SERVICE LETTER

SL No. **L-410/022**

Aeroplane Type: **L-410**

Reason: Newly developed set of oil cooler covers, B596 570N Index E – front air cooling inlet cover, B596 571N Index C – rear air cooling inlet cover and B596 572N Index F – oil cooler body insulation.

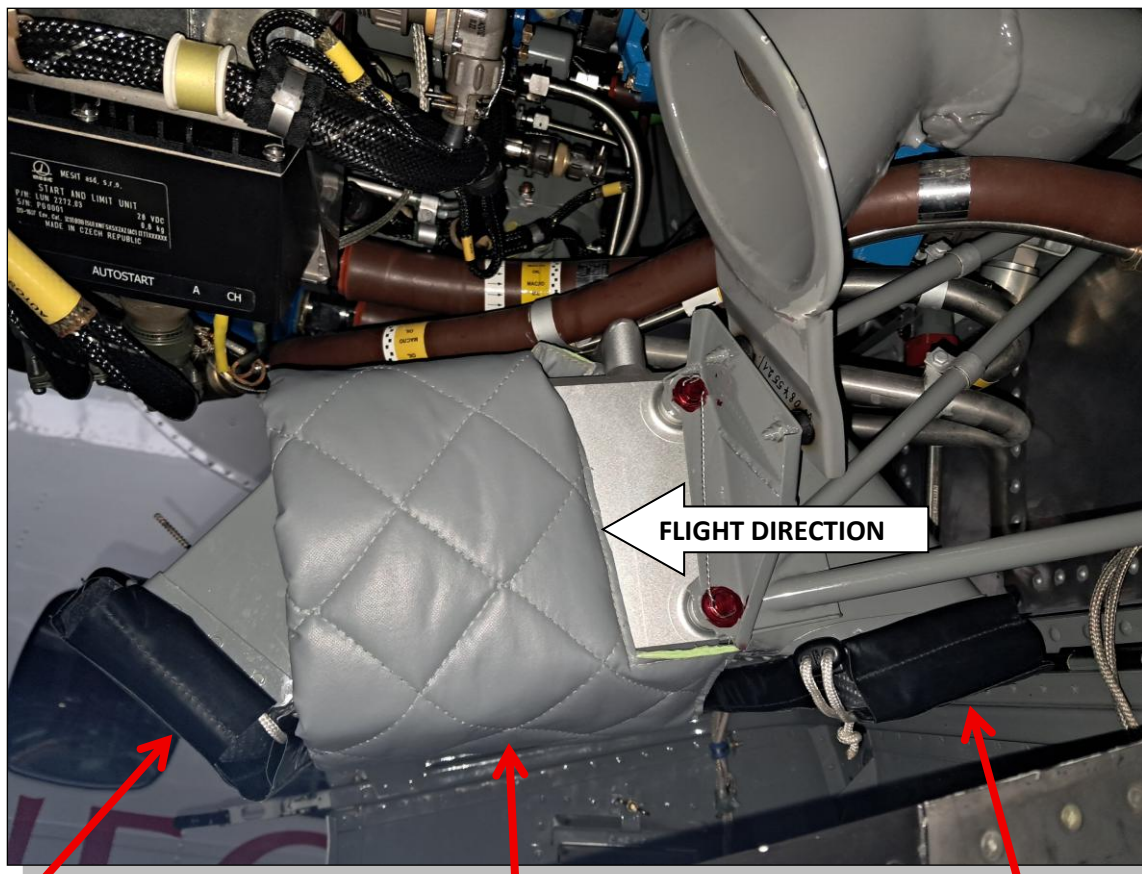
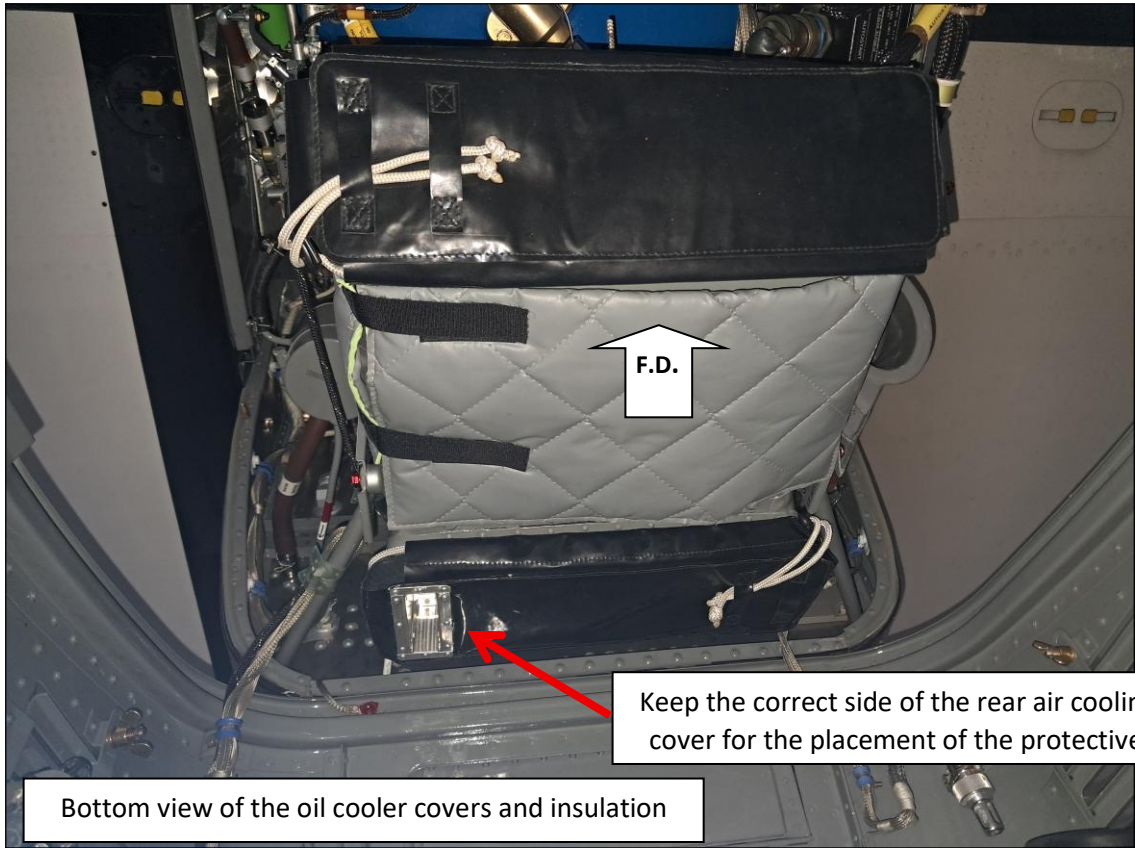
Description: When using original oil cooler covers set: B596 570N Indexes A to D, B596 571N Indexes A to B and B596 572N Indexes A to E there may be possible difficulties with securing inlet covers or installation of covers on the body of the oil cooler.

The sewing patterns of the cooling air inlet covers and oil cooler body covers have been improved for a better fit.

Front air cooling inlet cover –
B596 570N Index E

Oil cooler body insulation –
B596 572N Index F

Rear air cooling inlet cover
– B596 571N Index C
